**CAP 661**

**Mandatory Permit Directives**

**For Aircraft Operating on a Permit to Fly**

REVISION TRANSMITTAL SHEET ISSUE NO 2012/1 DATED JANUARY 2012

Figure 1

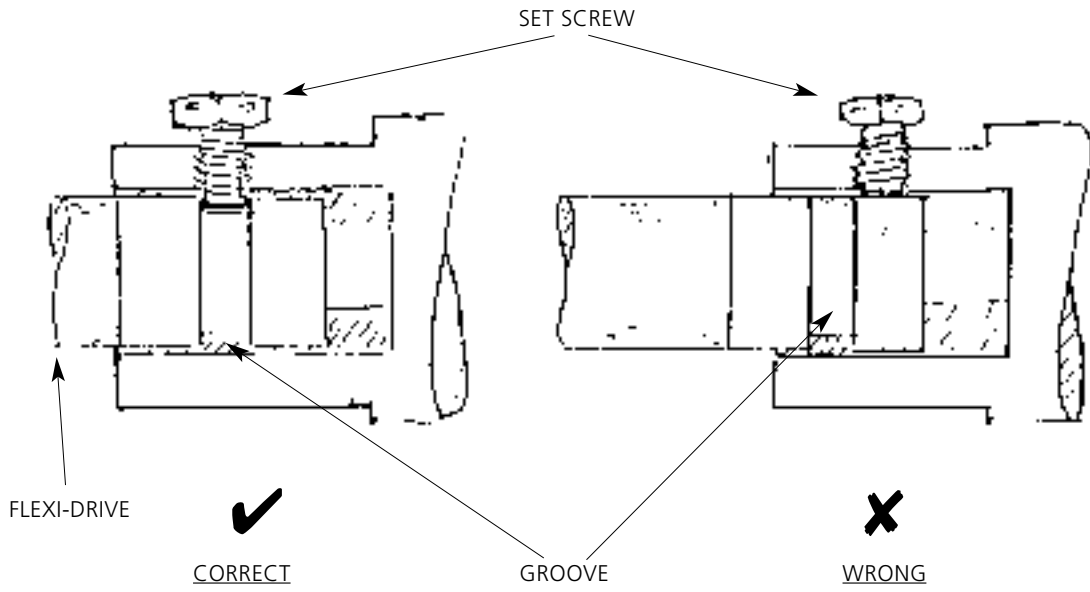
- (a) Remove the set screw, having first noted the amount of aluminium end ferrule projecting from the end socket. This should correspond with the distance of the centre line of the tapped hole normally occupied by the set screw from the face of the socket. If these dimensions do not correspond, the flexible drive shaft is incorrectly fitted, as it is possible to clamp the drive shaft ferrule at positions away from the groove in such a way that the drive is held by friction instead of positively located by the set screw in the groove. (See Figure 1).

Figure 3

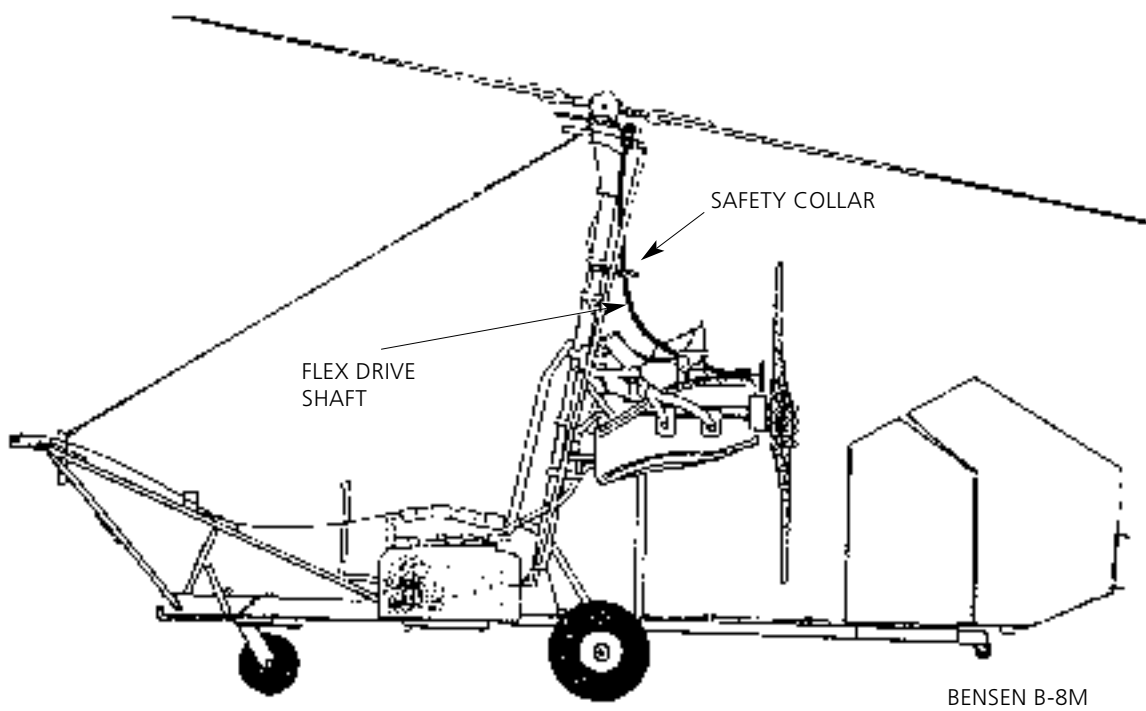
- (b) Check that the set screw has a flat face at the threaded end. If it has a domed end like a normal bolt, this must be refaced to allow full engagement in the groove in the ferrule. (See Figure 2).

Figure 4 Pre-Rotator Drive Safety Strap

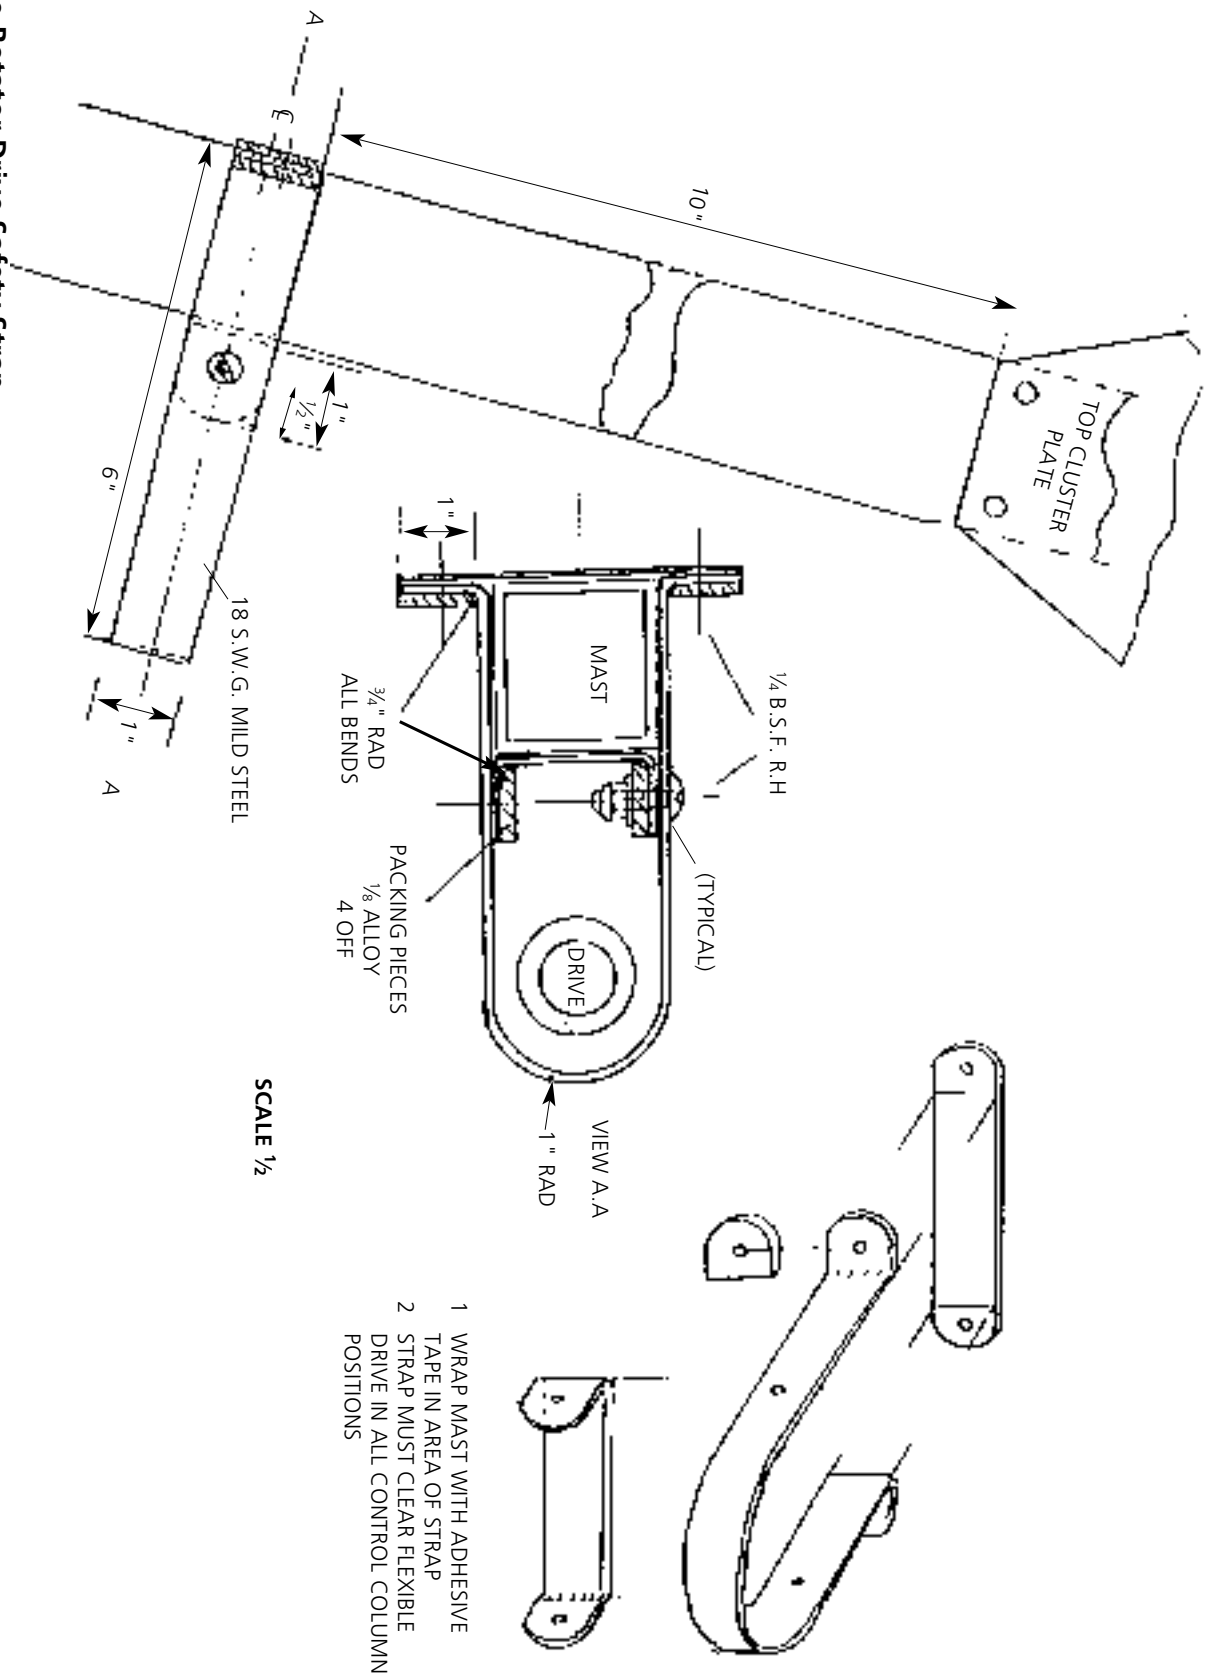
- 2 Check that the flexible drive shaft is correctly restrained in position on the aircraft by a safety collar mounted on the rotor pylon positioned approximately 10" below the rotor head cluster plates. (See Figure 3). This safety collar is a loose fit around the shaft which must be able to move freely up and down as the flying controls are moved. (See Figure 4).

Figure 1

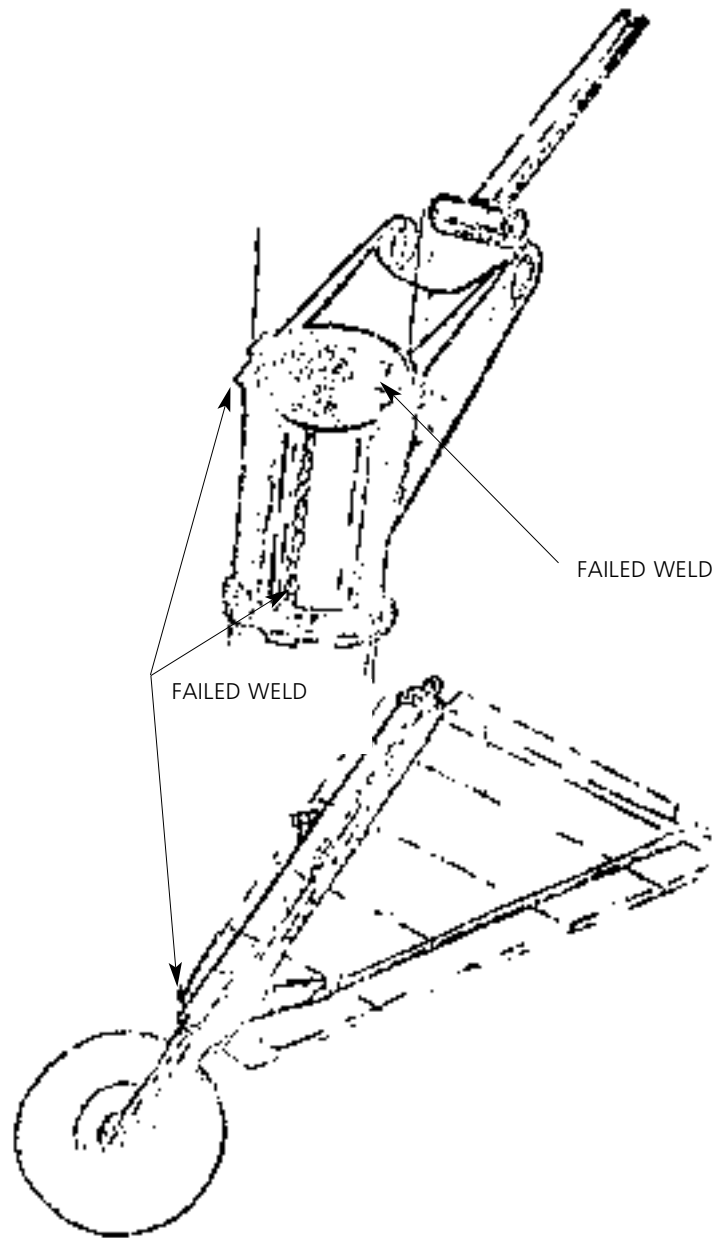
Compliance: At the next opportunity and thereafter following any heavy landing and at each Permit to Fly renewal inspect the landing gear welds for cracking. (See Figure 1 overleaf).

Figure 1  
Avon Mk. 203 & Mk. 207  
Right hand auxiliary gearbox drive

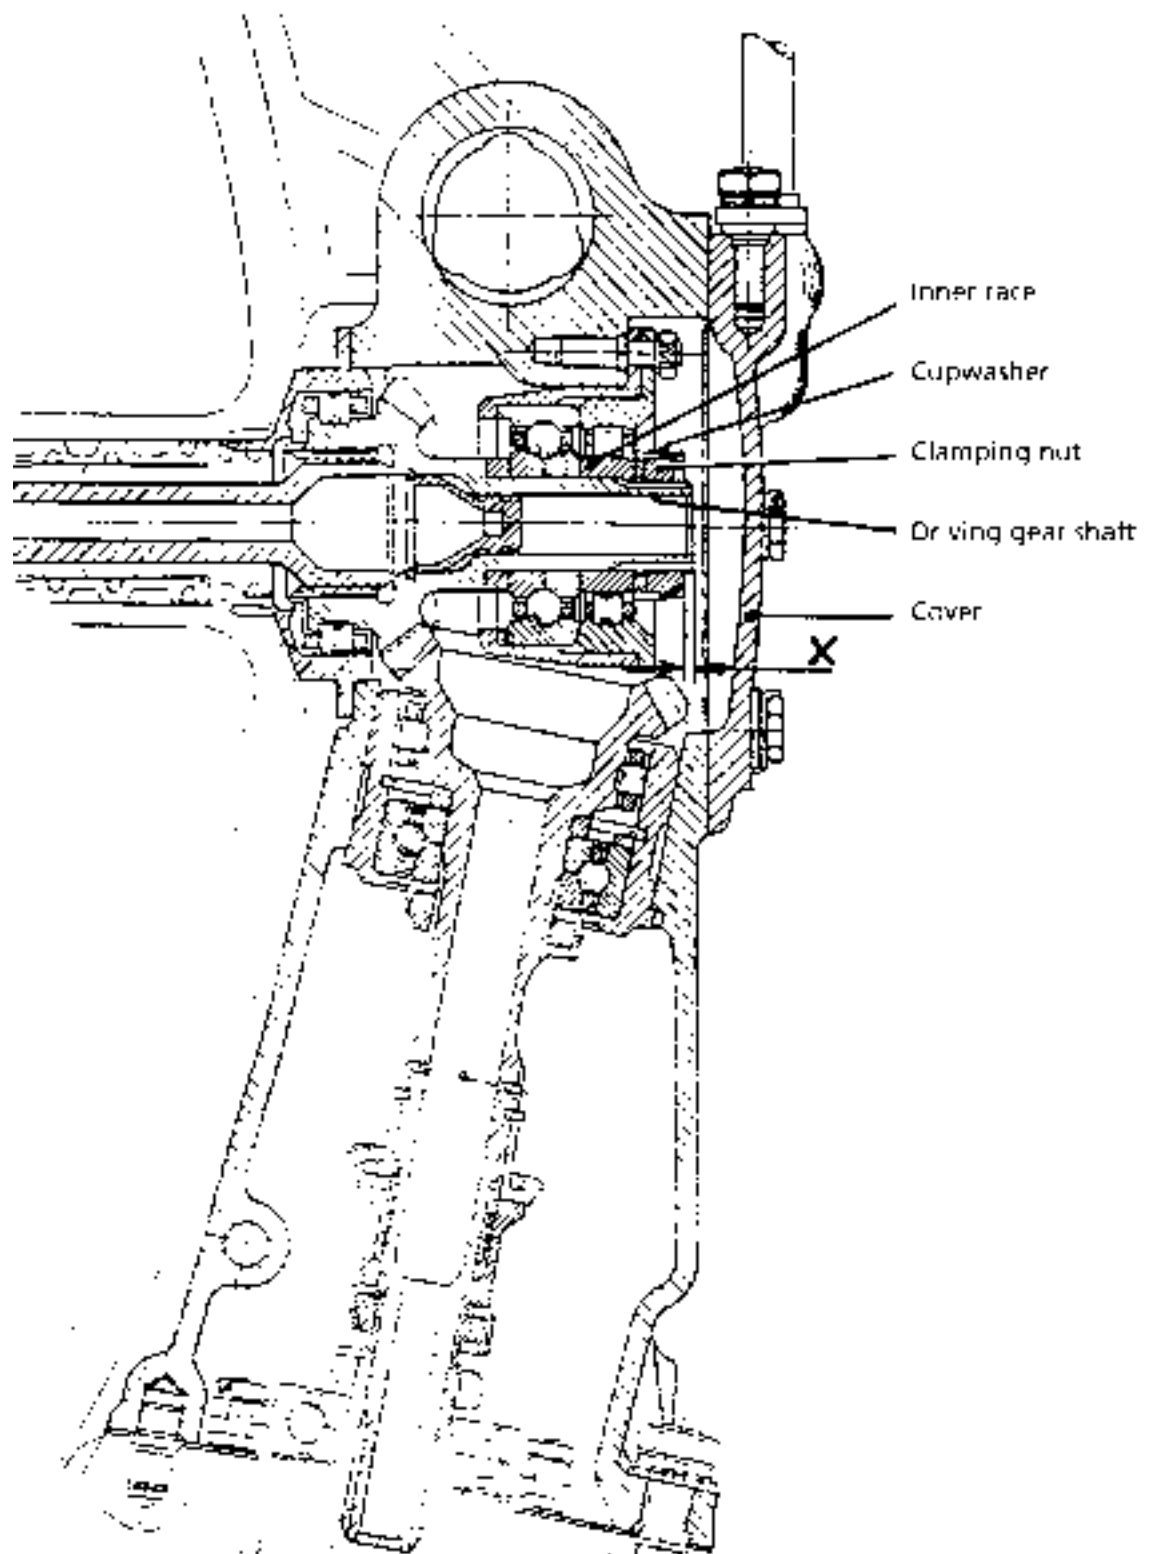
- 4 Measure the protrusion of the end face of the shaft from the end face of the nut (dimension X in Figure 1). If this dimension is 0.120"(3.0 mm) or less, the cover can be replaced, using new tabwashers and fresh jointing compound and the engine returned to service.
- 5 If the dimension is greater than 0.12"( 3.0 mm) this is an indication that the inner race may be missing and the gearbox is to be removed before further flight. If, on subsequent strip, the inner race is found to be missing, the bevel gear drive train is to be replaced before being refitted to an engine. (See Note 2).

**Figure 1 Plan view of Augmentor and By-Pass Valve Joint Washer**

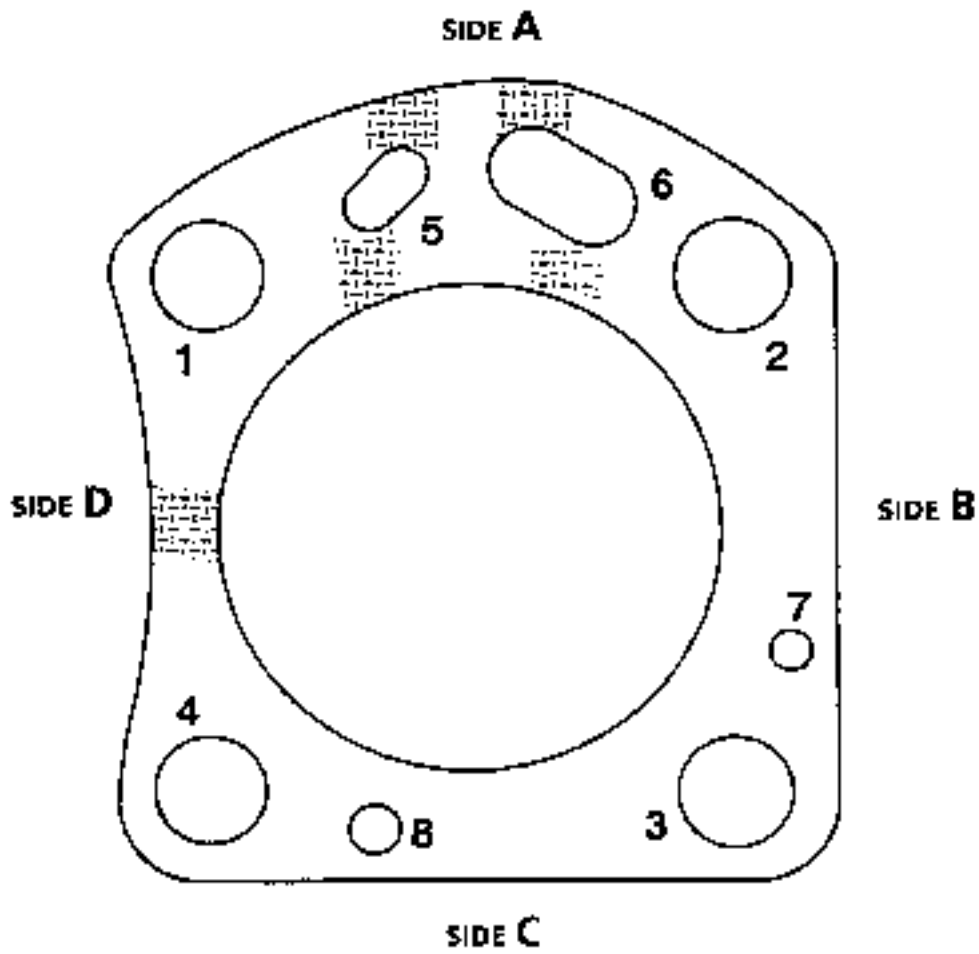
Internal 'stray wires' produced in the manufacturing process, completely contained within the joint washer material and revealed by the x-ray inspection, are acceptable between holes 2 and 3 and holes 3 and 4 (refer to figure 1). Internal 'stray wires' are not acceptable between holes 1 and 2, and holes 1 and 4.

The alignment/waviness of the stainless steel matrix should be parallel within plus or minus 10 degrees relative to sides B or C (refer to figure 1). Variations between these limits at any position on the joint washer are permissible, provided that such variations are in the form of smooth curves or waves, with no more than one wave across the width or depth of the joint washer. Local variations to a maximum of plus or minus 20 degrees are permissible at the following positions:

FIGURE 1

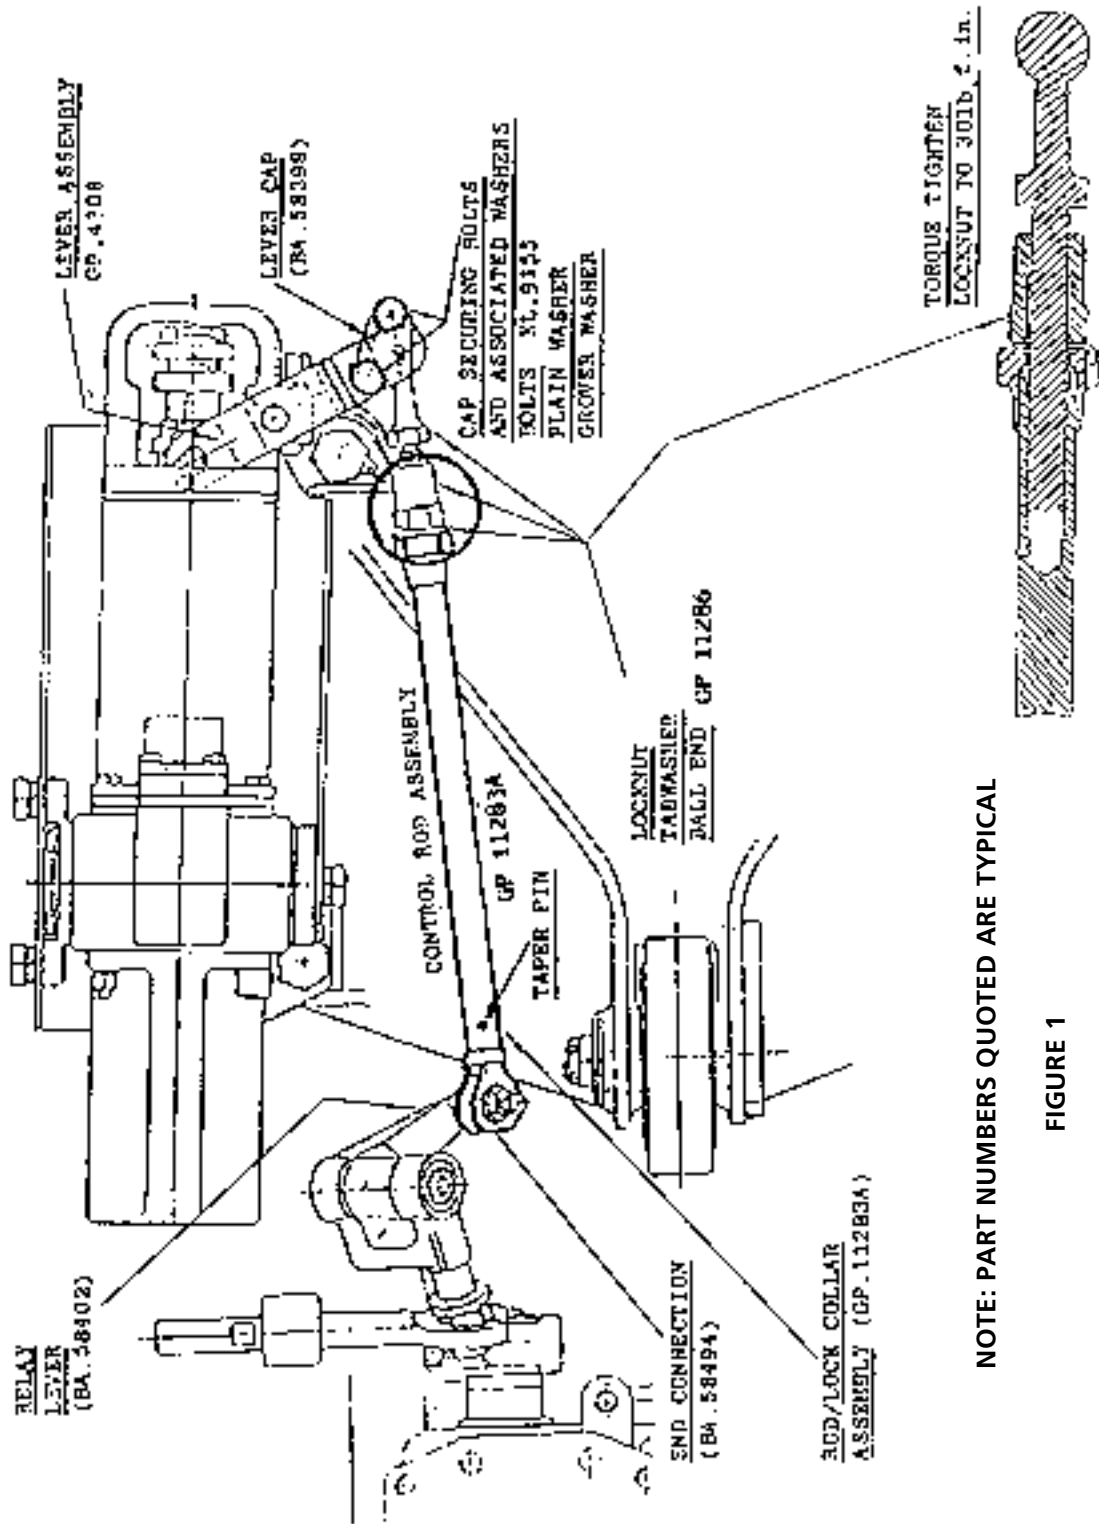
Reason: The CAA has recently been advised that an accident to a Hunter T7 in military service was attributed to disconnection of the top temperature controller control rod assembly (typical Part No. GP11283A) from its ball end piece (typical Part No. GP11286) (See figure 1). This disconnection led to loss of thrust control and eventual loss of the aeroplane. This MPD is issued to instruct a check on the assembly of the control linkage.

- 1 Gain access to the top temperature controller control rod assembly.
- 2 Examine the control rod for correct assembly.
- 3 Check the torque tightening on the nut securing the linkage. This torque should be a minimum of 30 lbf in as defined in STI/Avon/92. Do not disassemble the linkage if this torque level is satisfied.
- 4 If this torque level is not satisfied, inform the CAA, disconnect the assembly and inspect for signs of wear, or damage to the rest of the linkage. Evidence of wear or damage to the assembly is also to be reported to the CAA.
- 5 If no damage or wear is evident, reassemble the control linkage in accordance with instructions contained in AP 102-1512 to 1517-6A Section 2 Chapter 6 para 52-56B. STI/Avon/92 should also be consulted, since this contains necessary torque tightening information for the locknut.

A 72086 bracket showing the location of  
cracking

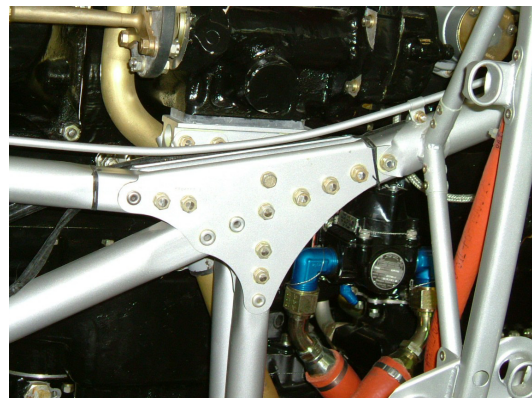
**Reason:** Cracks have been found in the engine mounting brackets of three Hurricane aircraft. A pair of brackets is installed on each side of the engine mount. The photographs below show the location of the cracks.

Cracks have been found in brackets of both the original design (part numbers A72086 and A72087) and the modified design (drawing AP1564B-M14-W/44). One aircraft was found to have cracks in three of the four brackets fitted. Brackets have been observed with plates attached to the outer surfaces of the triangular webs. If plates have been attached to the brackets, the inspection detailed in this MPD will not be effective and the CAA must be consulted for details of an appropriate inspection.

- b) If no cracks are found under a) or when the brackets are replaced with new brackets of either the original design (part numbers A72086 and A72087) or the modified design (drawing AP1564B-M14-W/44), inspect the brackets for cracks at intervals of 50 hours or every 24 months whichever is the shorter. If cracks are found during any of these inspections, the brackets are to be replaced with new parts. Note that if one bracket in a pair is found to be cracked, both brackets must be replaced.

Figure 1. General Arrangement of VPM M16 Fuselage Structure showing areas where cracks have been seen.

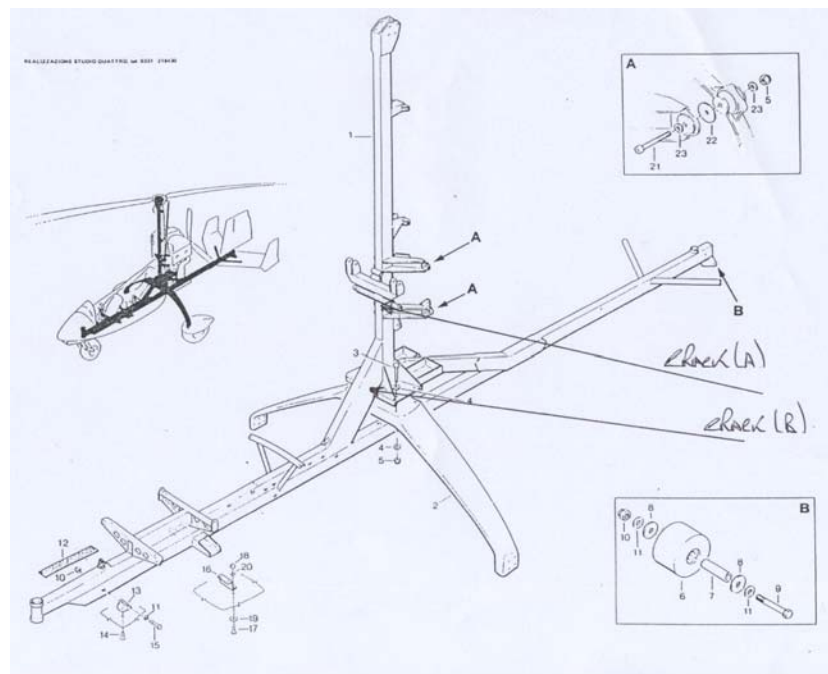
If cracks are found then the aircraft must not be flown and a full report submitted to the Light Aircraft Association. The manufacturers have indicated that a factory repair may be available on an airframe-by-airframe basis; advice should be sought from the UK agent (details overleaf).

If no cracks are found then the gyroplane may be returned to service.
